S2S and Coastal Protection. Updated March 2026

Coastal Protection Measures in Dublin Bay South

Fig 1: This shows the Irish Rail preferred proposal in 2024. It comprises a Rock Revetment with a raised sea wall as the basic protection of the Railway between Merrion Gates and Blackrock. There are other variations on it in sections between Blackrock and Dun Laoghaire

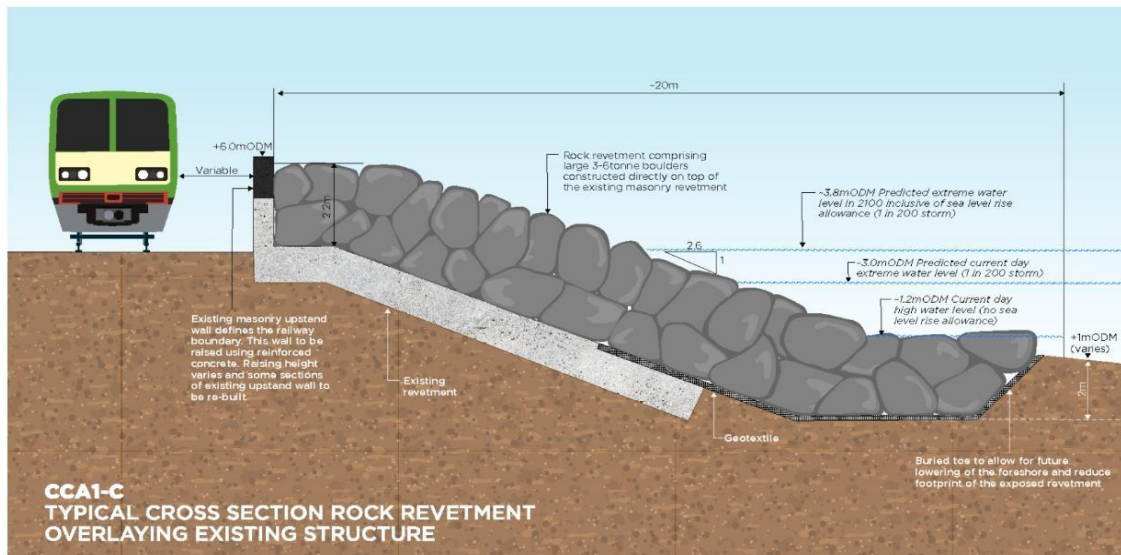
The **2024** NTA/Irish Rail study of this project concluded that a rock armour revetment was the most economic and effective way of achieving the necessary protection of the railway. **Ref. Fig 1.**

S2S suggests that NTA/Irish Rail revert to their 2024 preferred solution using rock armour, but to do so by first constructing a haul road. This is a common, practical and environmental approach that would reduce the cost and provide a permanent facility by which all the other objectives could be achieved. **Ref Fig 3**

Fig 2: This shows the new proposal in 2025- The Rock Armour is abandoned, the old sea wall demolished down to the level of the tracks and replaced with precast concrete slabs that will be about 1.3m higher than the existing wall making it about 3.0m high overall.

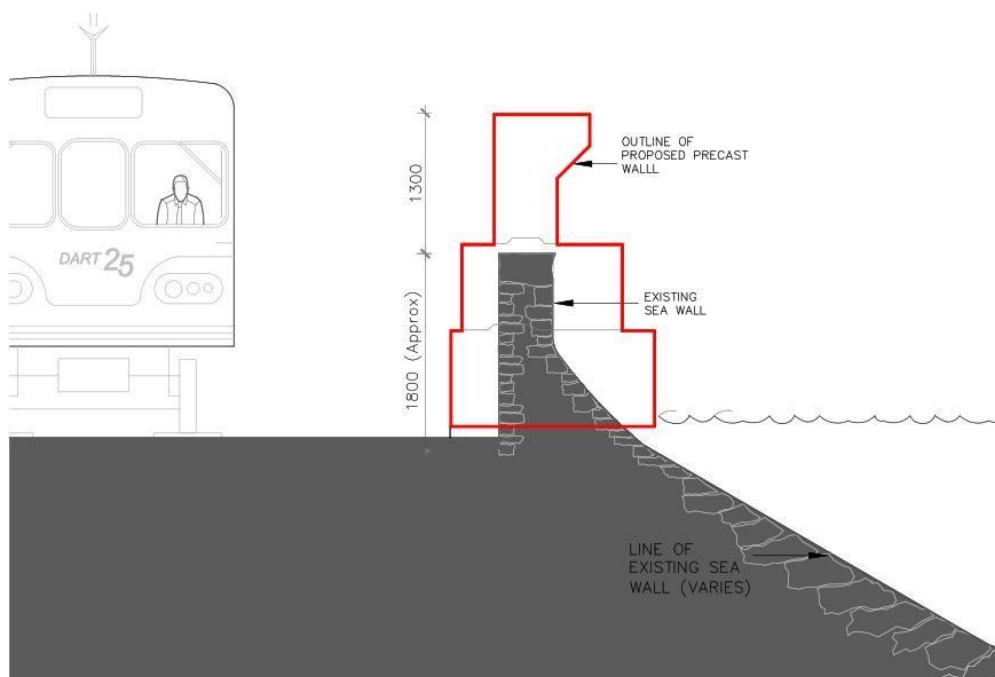
In the **2025** study that approach has been replaced by a plan to demolish the old sea wall down to the level of the tracks and to replace it with precast concrete slabs that will be about 1.3m higher than the old wall making it about 3.0m high overall. **Ref. Fig 2.** This will preclude other infrastructure objectives being incorporated. In addition, it will result in the view from the Dart being obliterated forever.

Fig 3: S2S Proposal: A similar Rock Armour Revetment including a haul road/permanent way that would accommodate a walkway/leisure cycleway and access for ongoing maintenance and repair of the railway and other infrastructure.

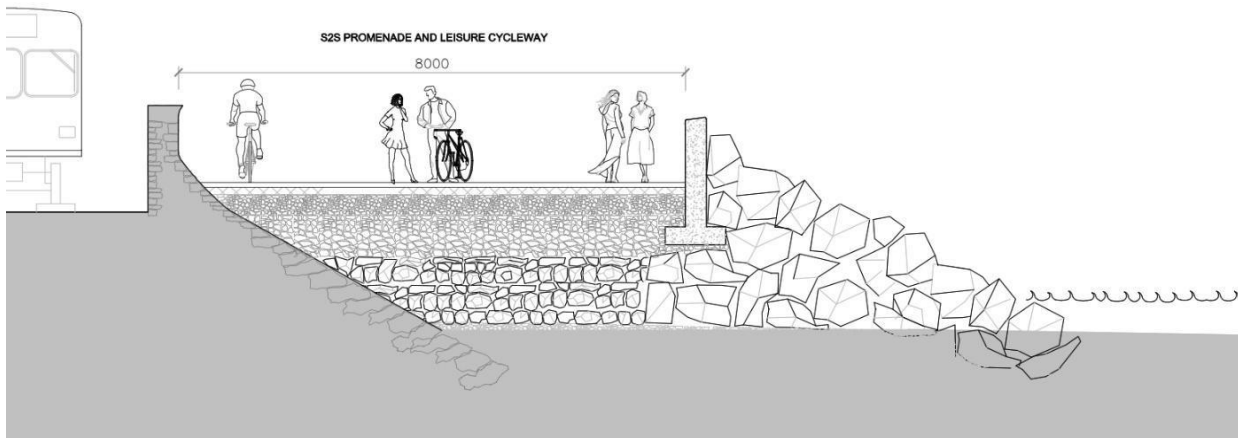
This would allow most if not all of the construction plant and materials to be brought to the worksite as the work proceeds. Critically it reduces the need to travel back and forth on the strand - with all the implications that would entail for the habitats. This is the method by which similar work has been carried out by Fingal County Council/ NTA/Irish Rail in Wexford Harbour and the Malahide Estuary. **Ref Appendix Fig 4**

Rock Armour is the traditional means of building effective marine structures - for good reasons. In a storm such as we have seen in recent days, when large waves meet a **vertical surface**, they explode up to twice or three times their original height. On-shore winds carry the spray over the top of the wall, causing flooding to the space behind. In some cases, they just knock the walls down as we have seen at Seapoint. Because of its sloping and rugged surface **rock armour** takes most of the energy out of the wave before it reaches the top - significantly reducing the over spray. By providing a space between the top of the slope and the railway line (in this case the walkway and cycleway) it allows the residual overspray to be collected and returned before it reaches the railway line.

Fig 5: The current proposed 8.5 km undersea route across Dublin Bay and an alternative 4 Km onshore route for the proposed Eirgrid 225 KV_a line from Carrickmines to Seam Moore Park. A further 1.6Km line could be laid along with the line from Inchicore to reach the substation at Poolbeg.

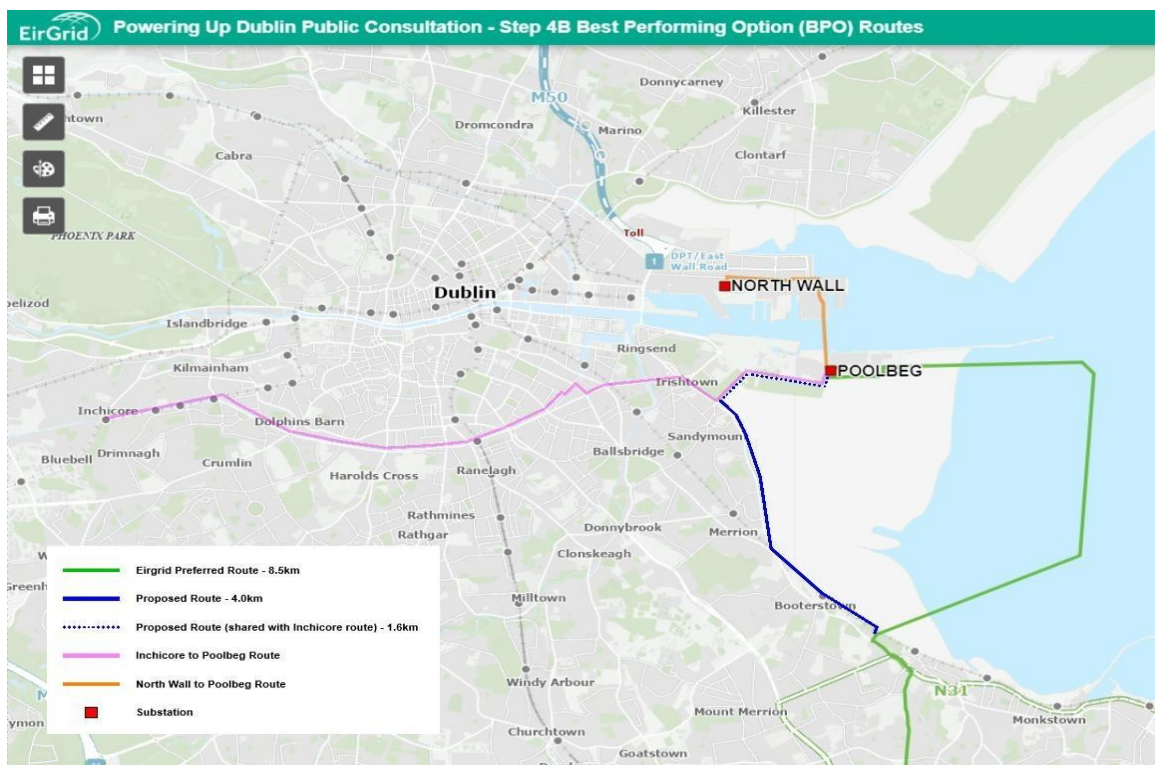
Although they have not yet reached that stage, it is obvious that all of them will have to do so before they can proceed. For stakeholders to pin their hopes on a single solution at this stage will inevitably lead to problems for those projects at subsequent stages. The Sandymount project is proceeding without reference to its potential to resolve the issue of the badly needed cycleway. Between Merrion Gates and Seapoint, several other objectives are being ignored, most importantly the 225KV_a Carrickmines to Poolbeg electrical link by Eirgrid. This is proposed to be laid in an 8.5km route in the seabed in Dublin Bay.

The same cable could be laid in a duct installed under the haul road along the coast. It could be incorporated in the works to the sea wall, it would be about 4kms long and be achieved at much less cost. All of these projects could be achieved by starting with a haul road. This creates a multi-function asset that would enable the protection of other public and private assets such as the ongoing planning by DLRC for Blackrock Seafront, Maretimo, Brighton Vale and Seapoint, all of which are currently excluded. Once the basic haul road is complete it would allow much of the finishing construction work to proceed every day, regardless of tides. It has the potential to significantly reduce the time and cost required to complete the work on all these projects individually. It could provide a route for the installation of public services and the routine maintenance of the railway and other public assets. Ref. Fig 5 and 6
